PRODUCT SERVICE NOTICE

2200 SVP OPTION W BOARD INSTALLATION

This PSN provides installation, checkout, and operating instructions for the optional 210-7486 Multi-Terminal SVP Board (Option W) used to replace the original 2200 SVP Board (P/N 210-7789). The Multi-Terminal SVP Board supports one, two, or three workstations and a printer. The original 7789 board supports only one workstation and a printer.

FCO NO.
1006

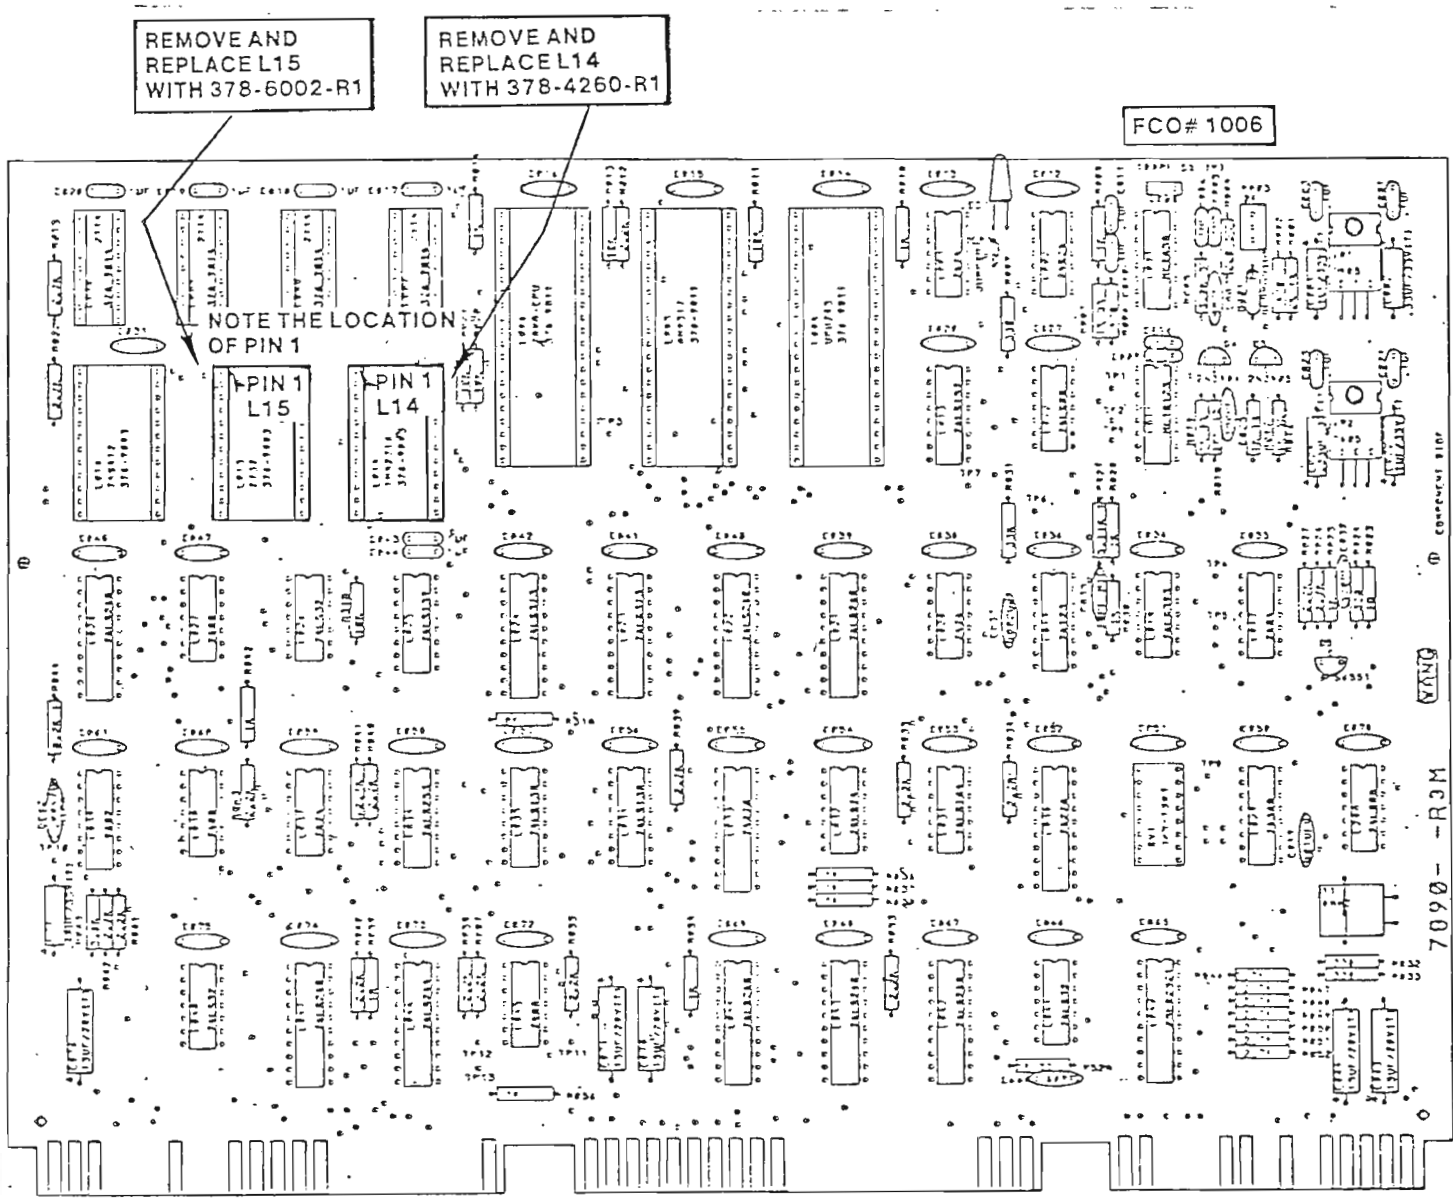
- * IBM routine was modified to correct the record handling capabilities.
- * DATASAVE BA function was modified to correct the I98 or I94 errors.
- * The disk format operation was modified to correct improperly reported format errors that may occur on the 26th sector.

- * The cache capacity was increased to improve the speed of sequential reads and sequential writes.
- * Improvements were made to increase verify speed.
- * RAM integrity is checked by background memory diagnostic.

- A. Ensure power is off. Remove the top cover of the 2200 SVP.
- B. Remove the 210-7890-A board.
- C. Remove EPROM's from locations L15 and L14.
- D. Replace EPROM's with 378-6002-R2 (L15) and 378-4260-R2 (L14) updated EPROM's. NOTE THE LOCATIONS OF PIN 1.
- E. Reinsert the 210-7890-A board into 2200 SVP unit.
- F. Run check-out procedures (See Section 6).
- G. Turn off power and reinstall the top cover.

FIGURE 1 SVP CHASSIS/REAR VIEW

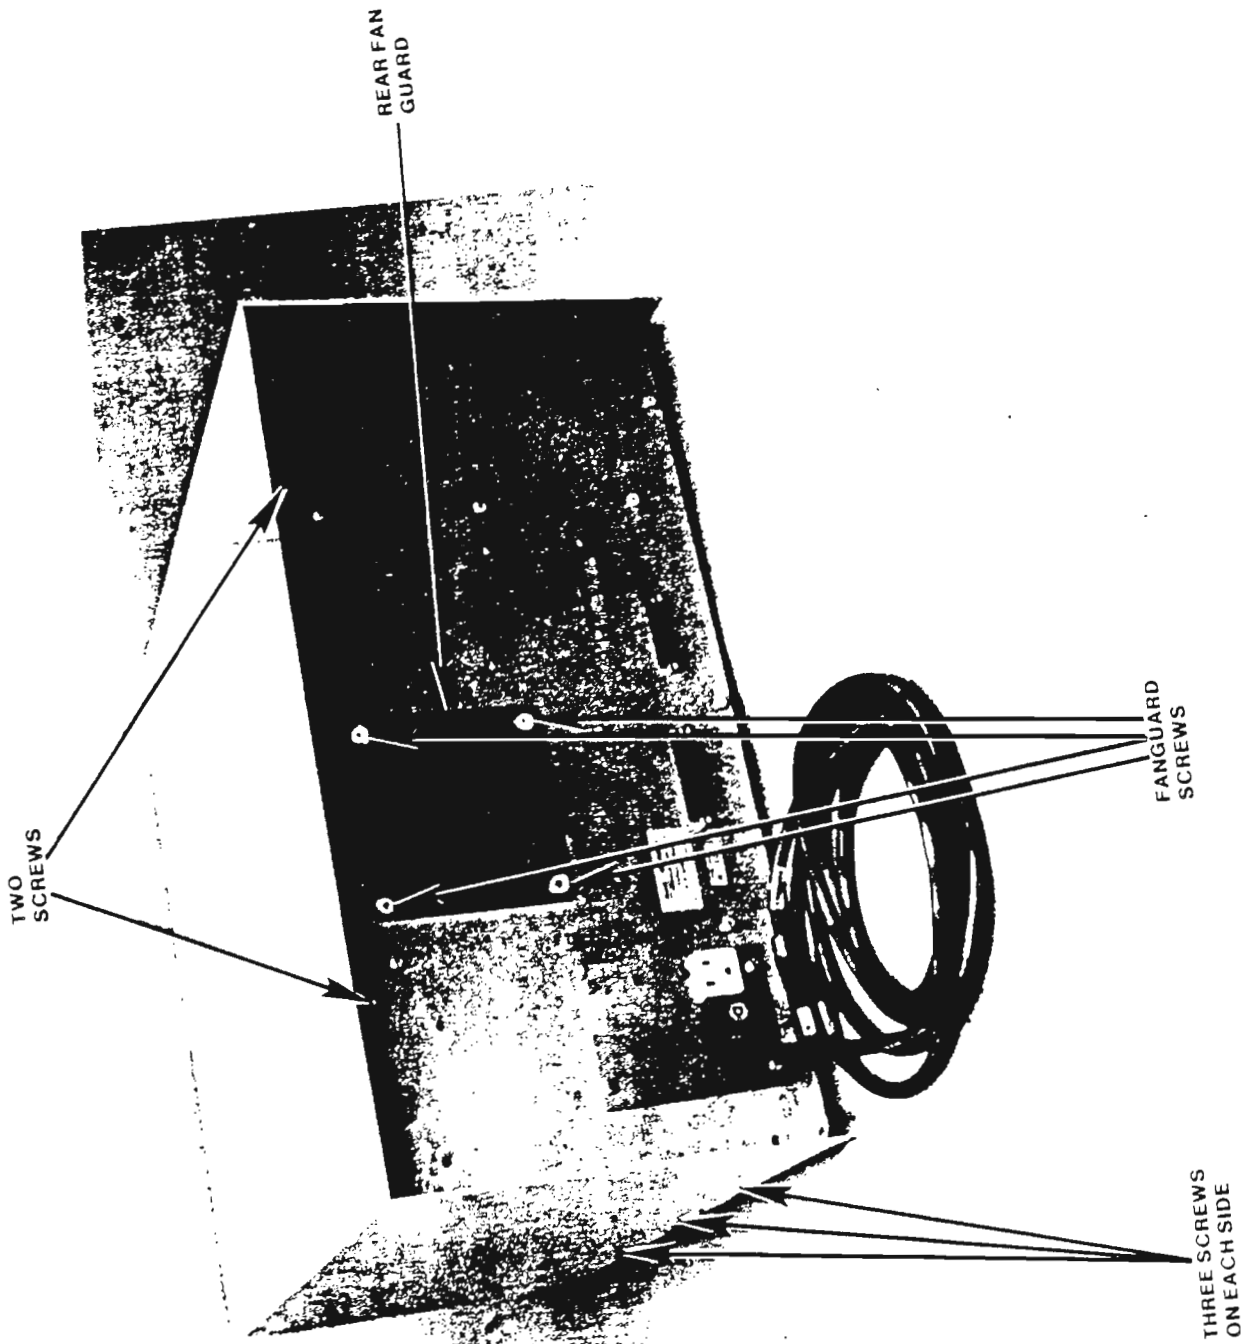
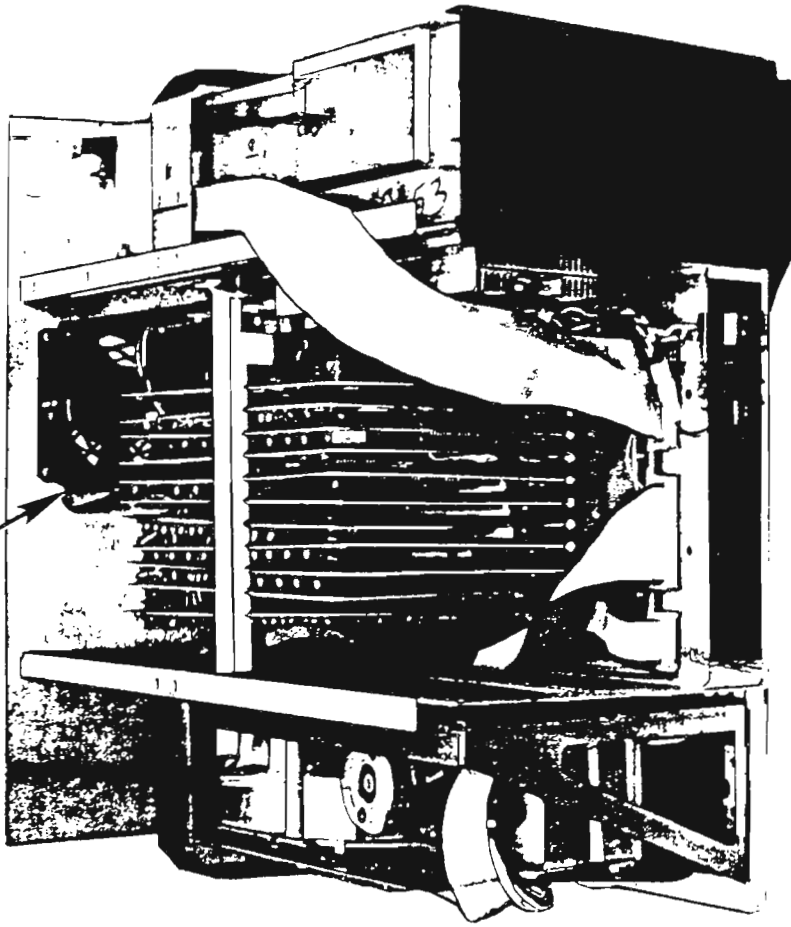
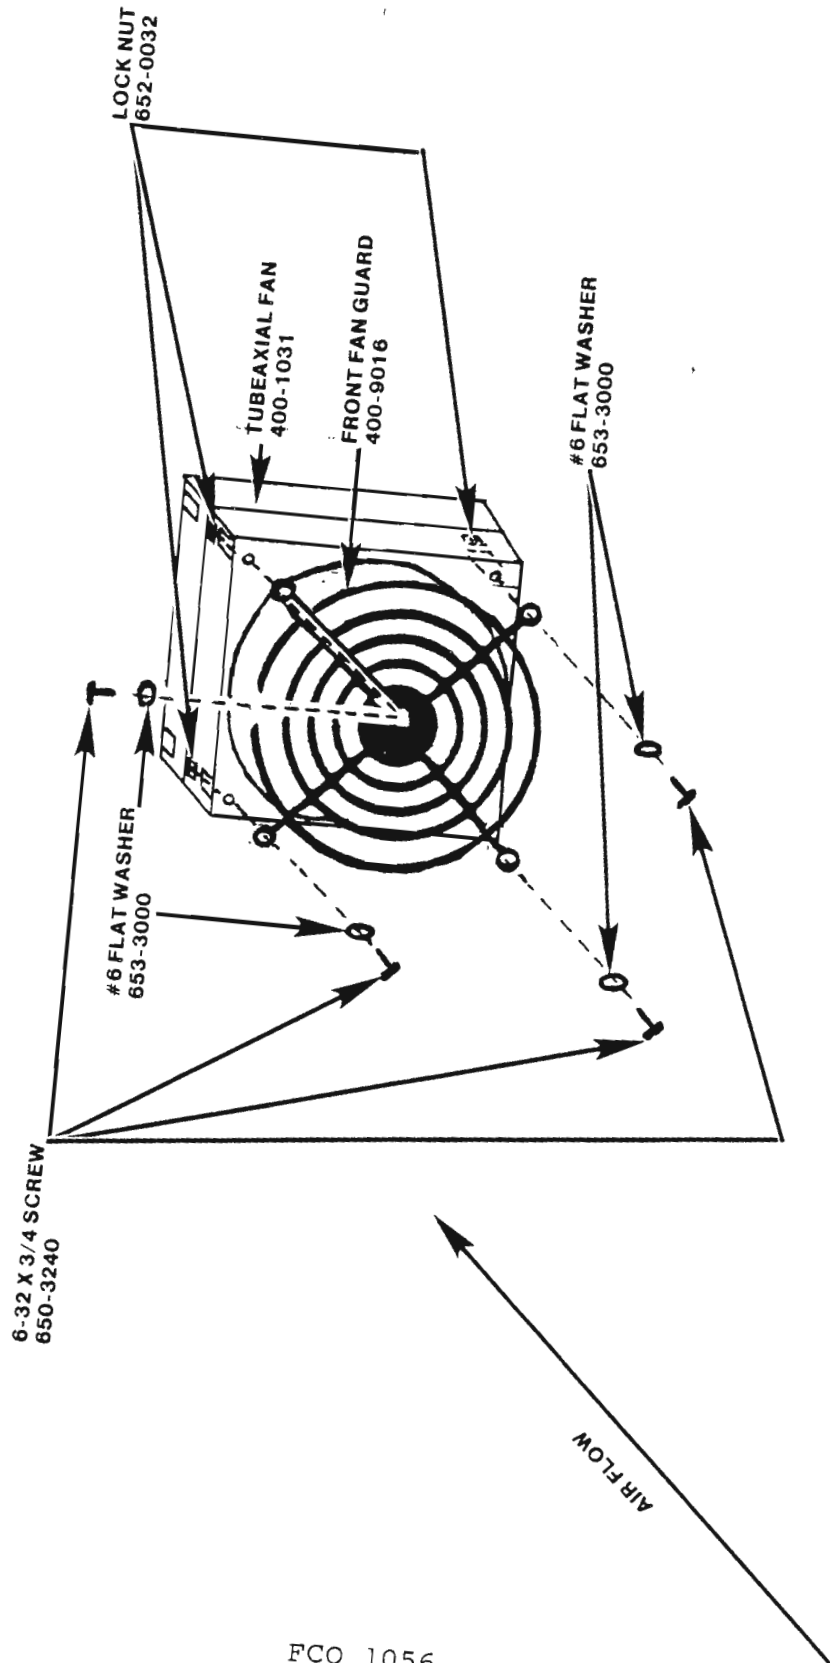
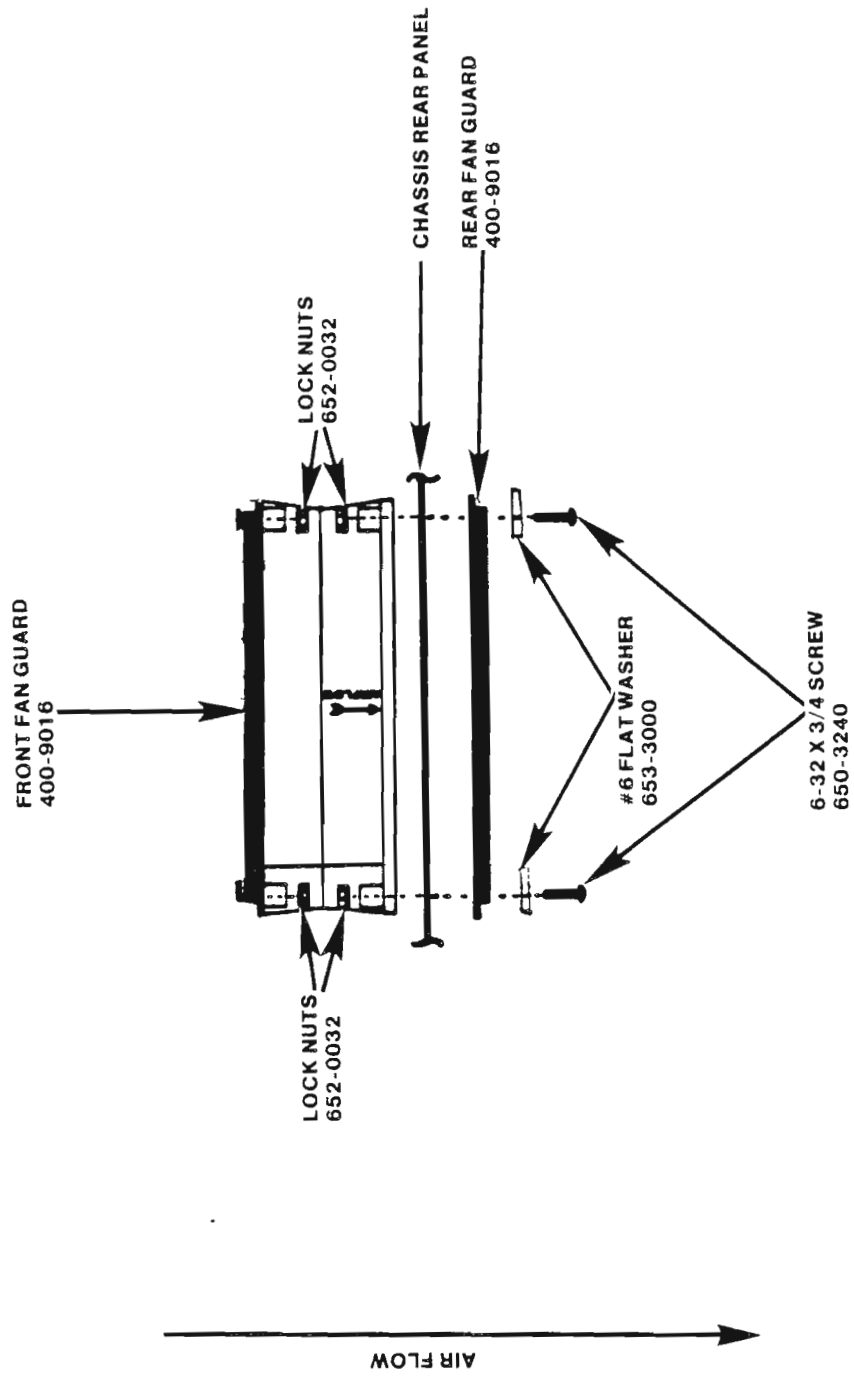
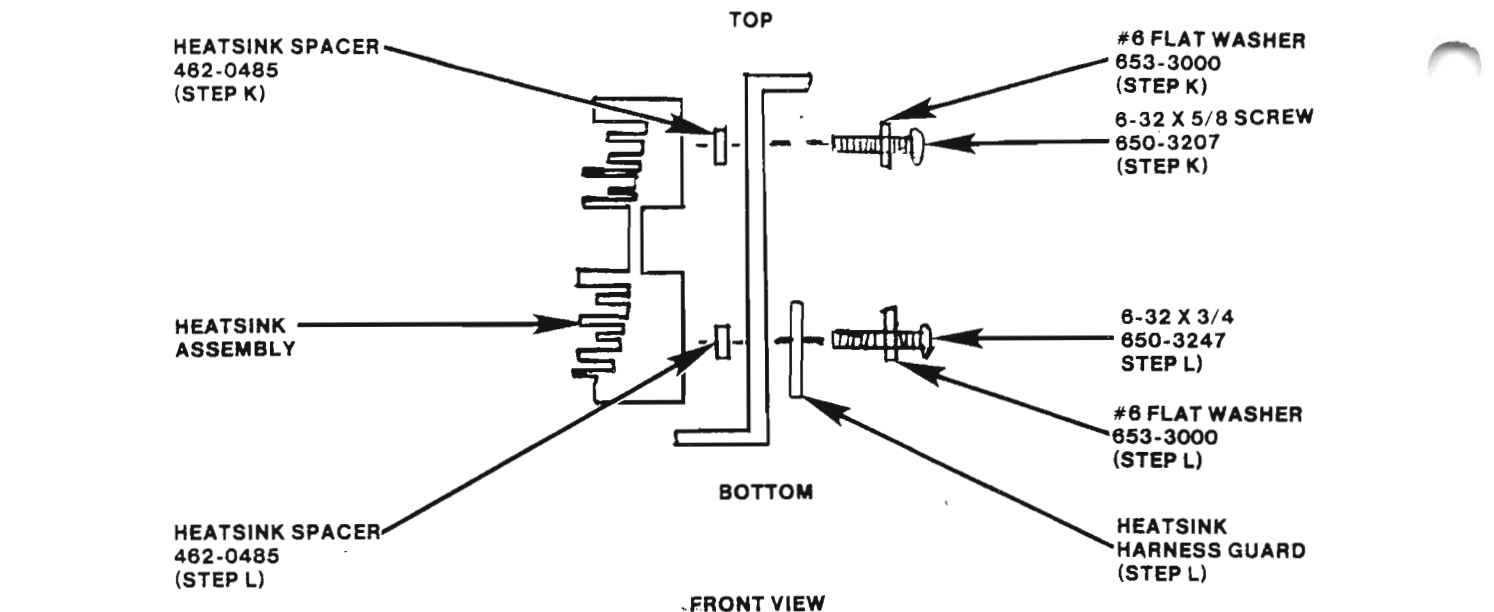
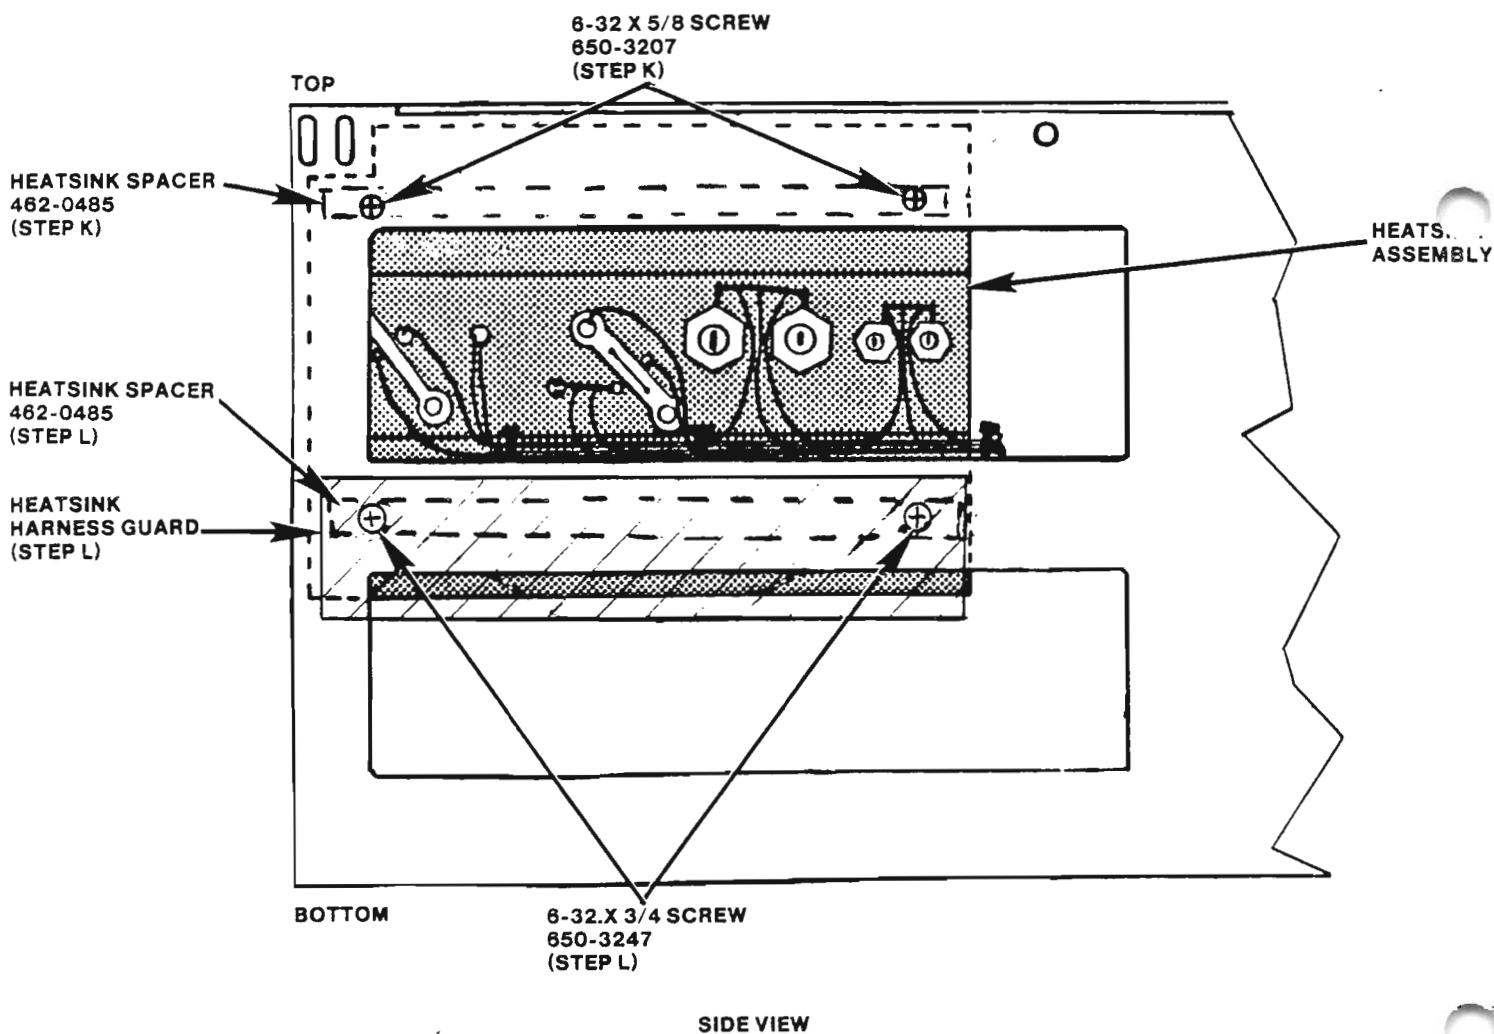
- A. The unit's 100 CFM fan is replaced by a 90 CFM fan.
- B. Plastic fan guards are replaced by metal fan guards.
- C. Two heatsink spacers are added to the heatsink.

- A. Power down the unit. Remove AC plug from wall.
- B. Refer to Figure 1. Using a Phillips screw driver, remove the six screws securing the sides of the cover (three on each side of the unit) and the two screws securing the cover at the rear of the chassis. Slide the cover toward the front of the unit and then lift the cover off.
- C. Refer to Figure 2. Remove the AC power plug from the plastic muffin fan at the rear of the chassis.
- D. Refer to Figure 1. Remove the muffin fan from the unit. To do this, take out the four screws, (650-3240) and lock nuts (652-0032) of the rear fan guard. Save the four screws and lock nuts to secure the new fan guard to the chassis in Step G below.

- E. Remove the four screws (650-3240) and lock nuts (652-0032) from the front fan guard of the muffin fan. Save the four screws and lock nuts for use in Step F.
- F. Refer to Figure 3. Insert four 6-32x3/4 screws (650-3240), saved from Step E, through four #6 flat washers (653-3000). Fasten one of the new fan guards (400-9016) to the front of the new 90 CFM tubeaxial fan (400-1031) with the four screws and four lock nuts (652-0032) saved from Step E.

- G. Refer to Figure 4. Insert four 6-32x3/4 screws (650-3240), saved from Step D, through four #6 flat washers (653-3000). Install the 90 CFM tubeaxial fan (400-1031) and the remaining fan guard (400-9016) on the rear panel of the chassis. To do this, hold the fan against the inside of the rear panel. When properly placed, the air flow indicator on the fan is at the top of the unit. Secure the fan by installing the fan guard on the outside of the rear chassis panel using the four screws and four lock nuts (652-0032) saved from Step D.

- H. Connect the AC power plug, shown in Figure 2, to the fan.
- I. Remove the diskette drive from the chassis using the procedures described in Section 11.6.3 of the manual.
- J. Using a Phillips screwdriver, remove the four screws that secure the heatsink to the chassis. This will also result in removal of the heatsink harness guard shown in Figure 5. (Some older units may not have a heat sink harness guard).

- K. Place a #6 flat washer (653-3000) on each of two 6-32x5/8 screws (650-3207). Position a heatsink spacer (462-0485) between the top of the heatsink and inside the chassis. Fasten the screws through the chassis wall, heatsink spacer and tap holes in the heatsink assembly. (Keep the screws loose to allow space for installation of the bottom heatsink spacer in Step L below).

- L. Place a #6 flat washer (653-3000) on each of two 6-32x3/4 screws (650-3247). Position the remaining heatsink spacer (462-0485) between bottom of heatsink and inside chassis wall. Position the heatsink harness guard in its original location. Fasten the screws through the heatsink harness guard, chassis wall, heatsink spacer and tap holes in the heatsink assembly.
- M. Tighten the 6-32x5/8 screws (650-3207) installed in Step K at the top of the heatsink.
- N. Reinstall the diskette drive by reversing the procedures described in Section 11.6.3 of the manual.
- O. Replace the cover by reversing the procedures described in Step B above.
- P. Connect AC to wall.
- Q. Perform Check-Out Procedure described in Section 6 below.
- R. Document installation of the FCO by completing a Call Report or Activity Report
